UPDATE CHANGE NOTIFICATION # 16361AGeneric Copy

Issue Date: 10-Apr-2012**TITLE:** Ordering Information Update for CAT24C02, 2Kb I2C Serial EEPROM**PROPOSED FIRST SHIP DATE:** 10-May-2012**AFFECTED CHANGE CATEGORY(S):** CAT24C02 (all packages, all temperatures)**ADDITIONAL RELIABILITY DATA:** N/A**SAMPLES:** Contact your local ON Semiconductor Sales Office**FOR ANY QUESTIONS CONCERNING THIS NOTIFICATION:**Contact your local ON Semiconductor Sales Office or Denisa Stefan
<denisa.stefan@onsemi.com>**NOTIFICATION TYPE:**

Top package Marking CAT24C02 (Gresham die based)

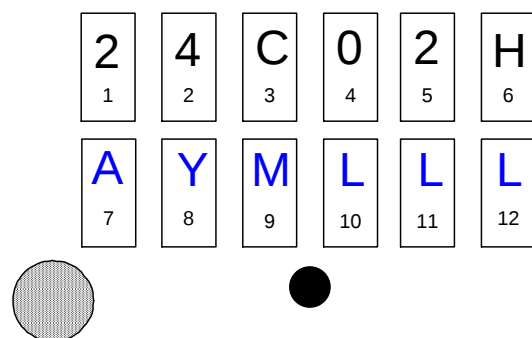
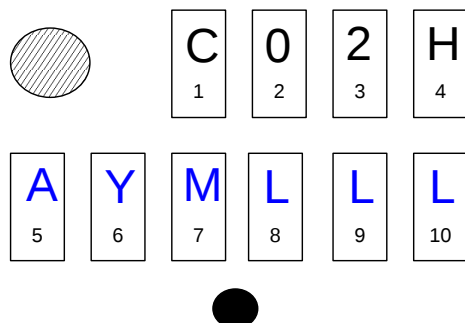
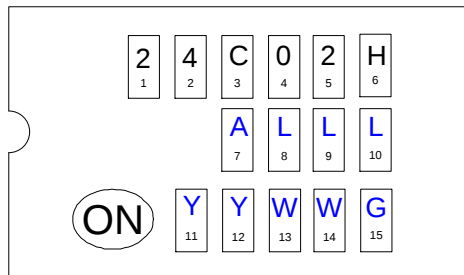
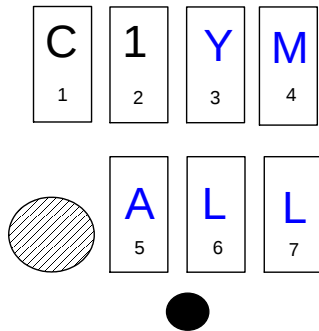
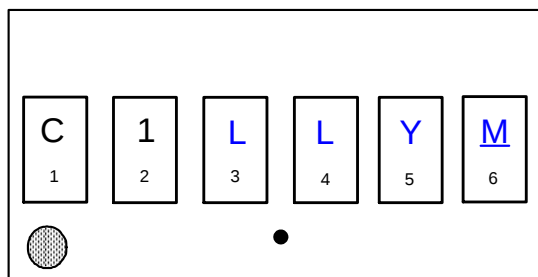
The package marking will follow the actual top package marking used for the CAT24C02 Gresham die based, as shown in the Appendix.
